TOWN OF ACTON
472 Main Street
Acton, Massachusetts, 01720
Telephone (978) 264-9628
Fax (978) 264-9630

Engineering Department

Subject: Review of Mohegan Lane Subdivision – 37 Mohegan Road - Definitive Subdivision Plan

We have reviewed the plans for the above mentioned project titled “Definitive Subdivision Plan for Mohegan Lane” dated December 16, 2015 and have the following comments:

SITE DEVELOPMENT AND GRADING PLAN
FOR: JEANSON
SCALE: 1"=20'
DATE: MARCH 25, 2016

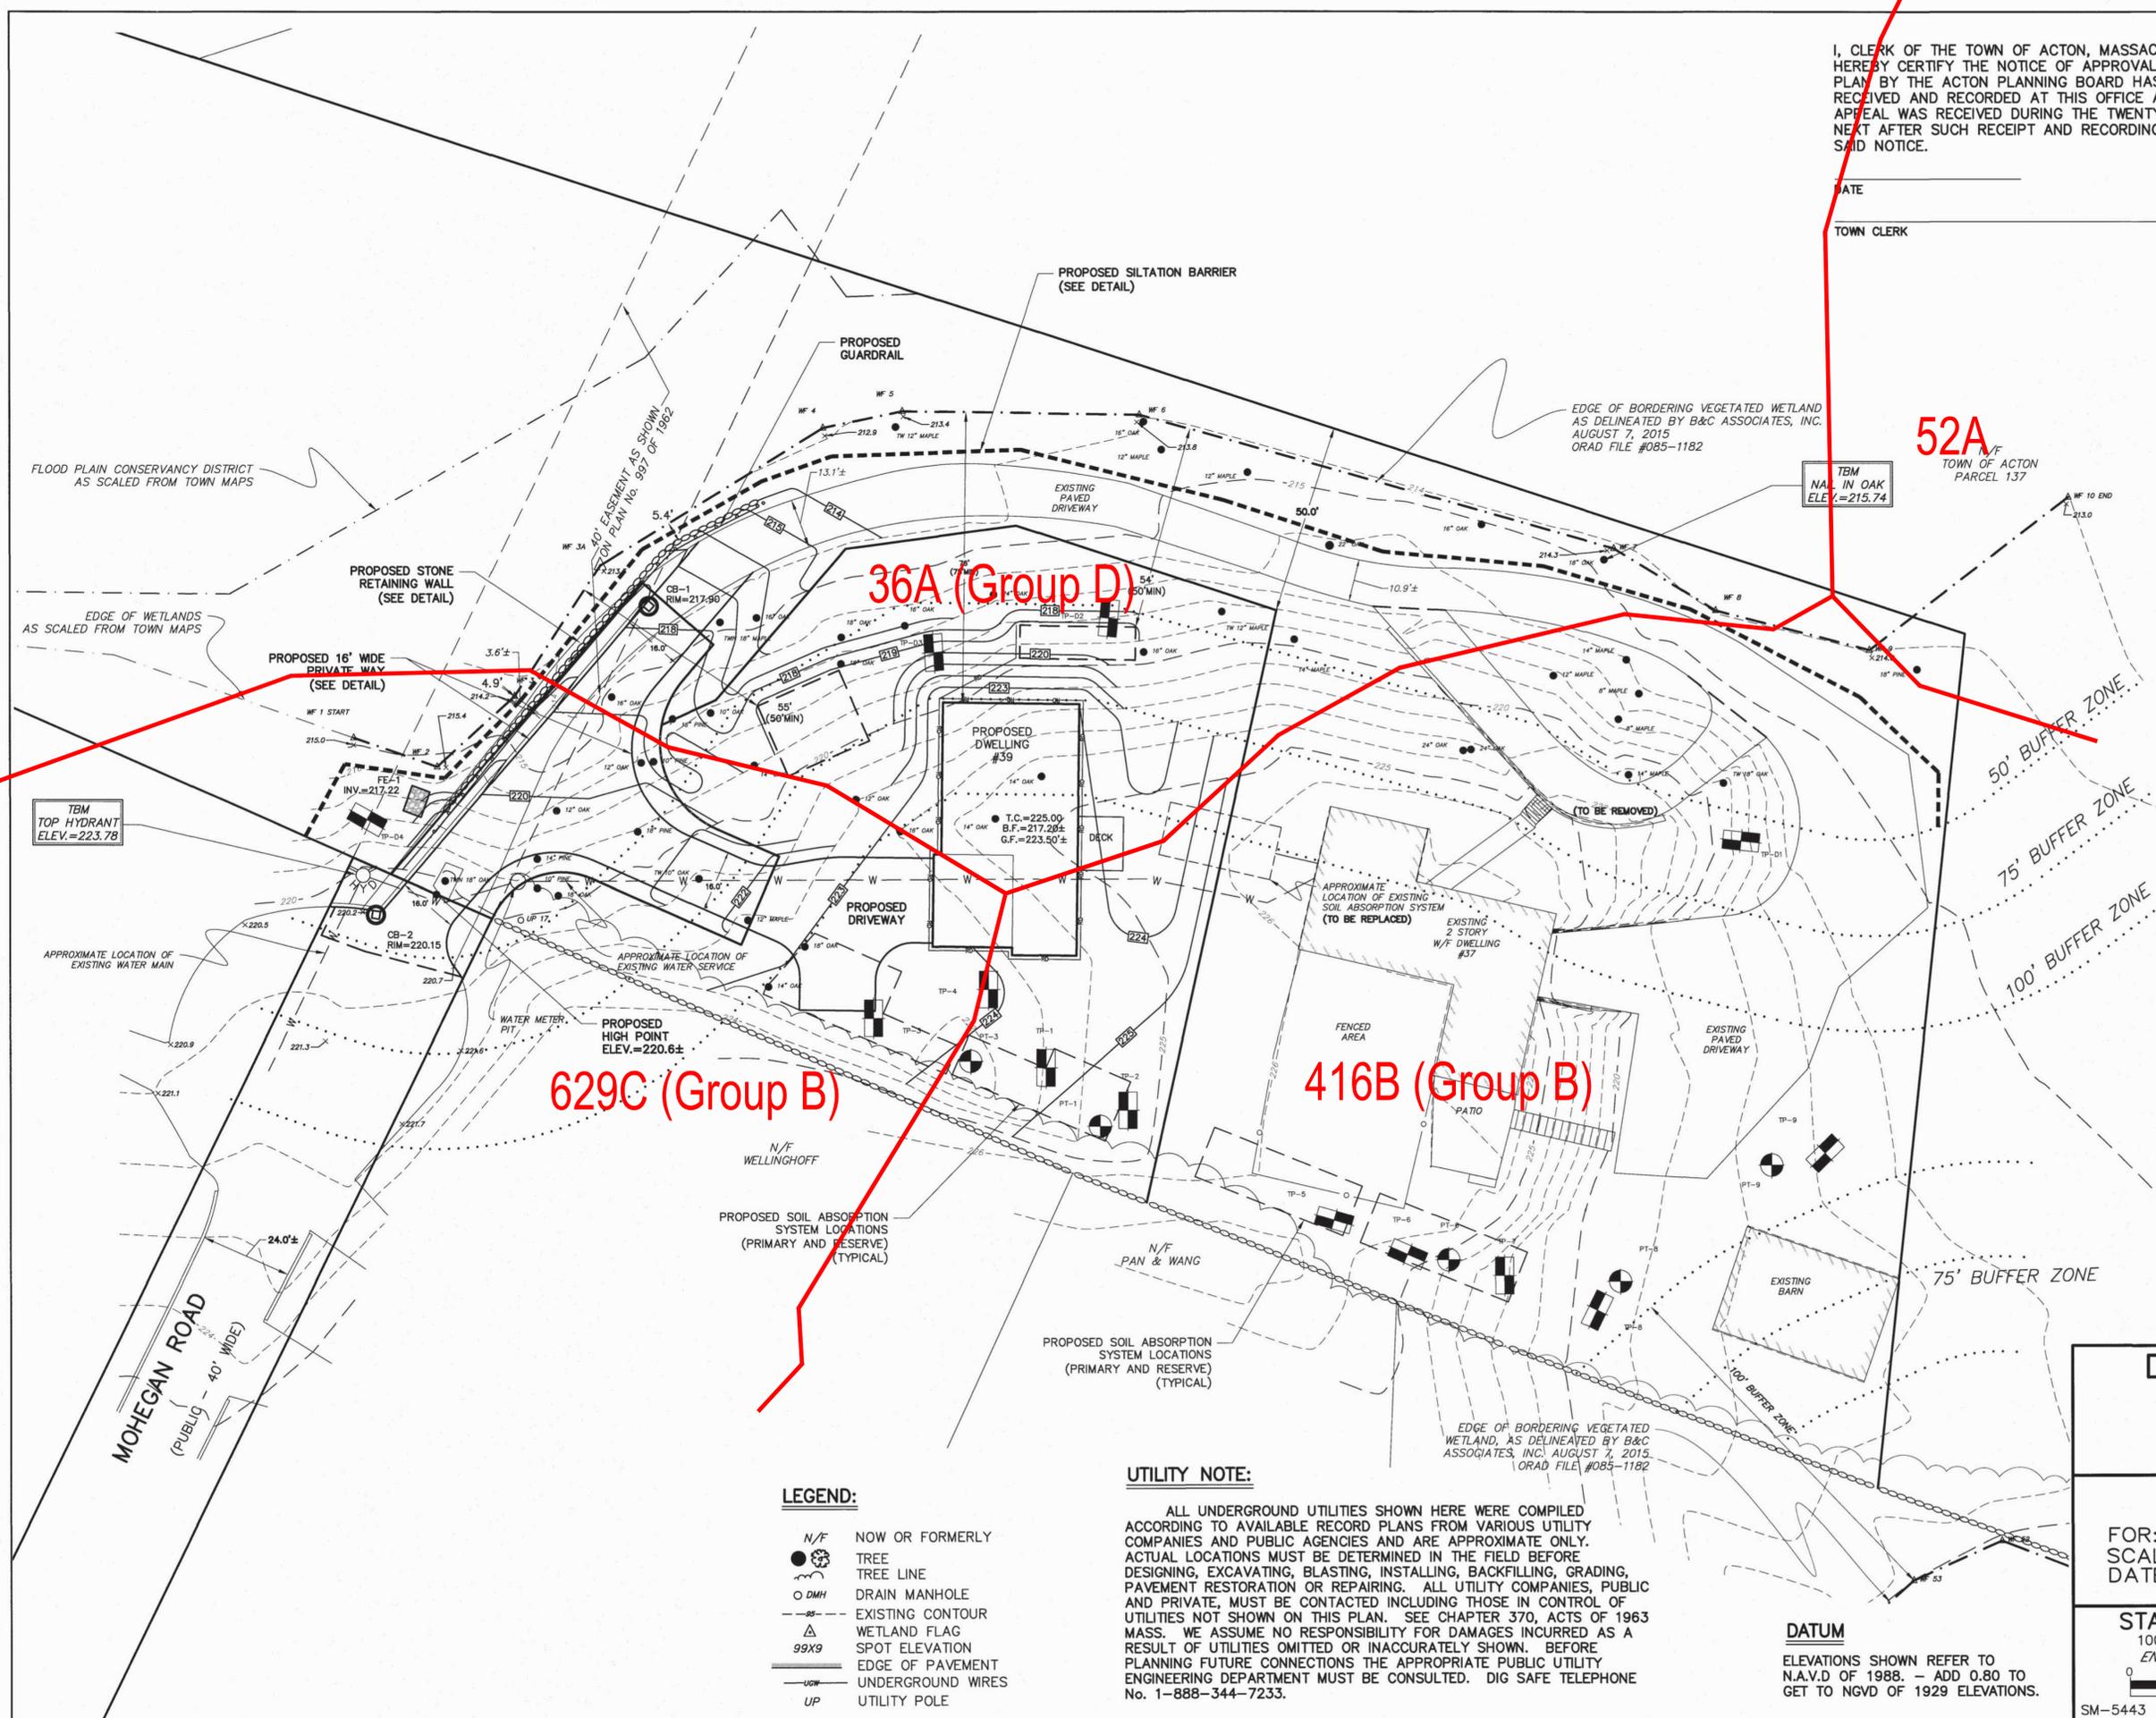
2. Based on the turning templates shown on the plan, the common driveway appears to be adequate for an SU-30 truck. We will defer to the Fire Department regarding the proposed turnaround.

As we said in our Preliminary Subdivision comments, the portion of the site where the applicant is proposing the underground detention system is "very poorly drained" (Group D). The extent of the Group D soil is most likely the edge of wetlands however 629C and 416B soils are Group B soils, not Group A as stated in the stormwater report. The exfiltration rate of 8.27 in/hour as shown in the report is for Group A soils, not B or D.

The soil classification affects all stormwater calculations including: estimated stormwater runoff rate, runoff volume and the required size of the underground detention system. Without the correct soil classification, we cannot confirm that the drainage system has been designed properly.

7. The time of concentration paths aren't shown on the drainage maps
